Sea-Bird Electronics, Inc.
 13431 NE 20th Street
 Bellevue, WA 98005
 USA

APPLICATION NOTE NO. 86

February 2007

Change to SBE *9plus* CTD Bottom Contact Switch Connector (JB6)

SBE 9plus Bottom End Cap

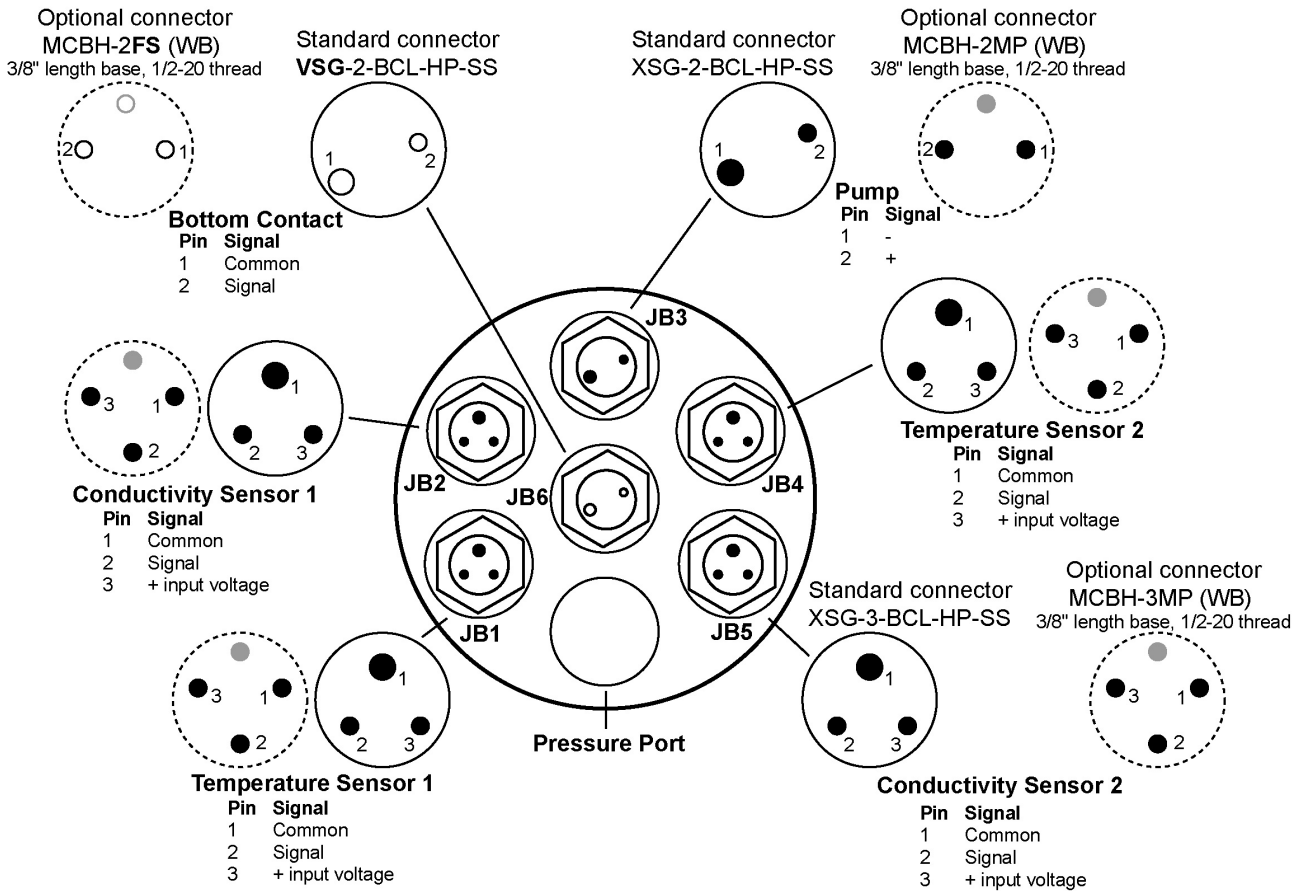
The *9plus* is usually deployed with a dummy plug on the JB6 bottom contact connector (because most customers do not use a bottom contact switch). Over the years, a small number of customers have mistakenly removed the dummy plug and plugged the 250-volt sea cable into JB6, causing extensive damage to the electronics that renders the *9plus* inoperable until one of the PCBs is replaced. To prevent this expensive user error, **all** SBE *9plus* CTDs built after mid-February 2007 will use a 2-pin **female** bulkhead connector for JB6 to differentiate JB6 from the JT1 sea cable connector.

For existing SBE *9plus* CTDs, Sea-Bird will change the JB6 bottom contact connector on request, at our usual price for this type of work. Note that a new dummy plug and (if applicable) a new cable to a bottom contact switch are also required if the connector is changed. **Contact Sea-Bird for pricing and for scheduling information.**
